DESCRIPTIVE REPORT

Type of Survey Hydrographic
Field No. RA-20-04-99
Registry No. H-10882

State Alaska
General Locality Lynn Canal
Sublocality Northern Approach to
Chatham Strait

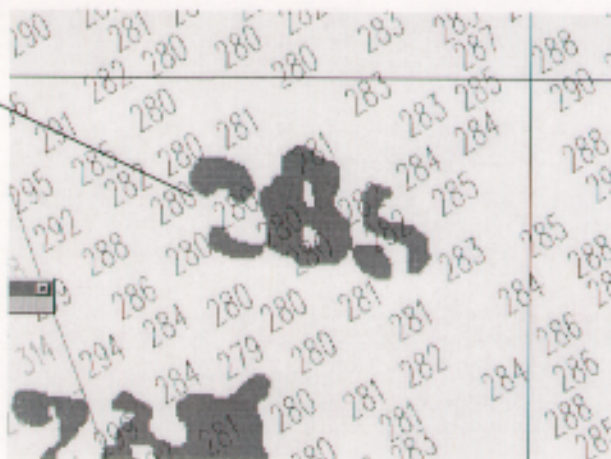
This depth was misread as 265.
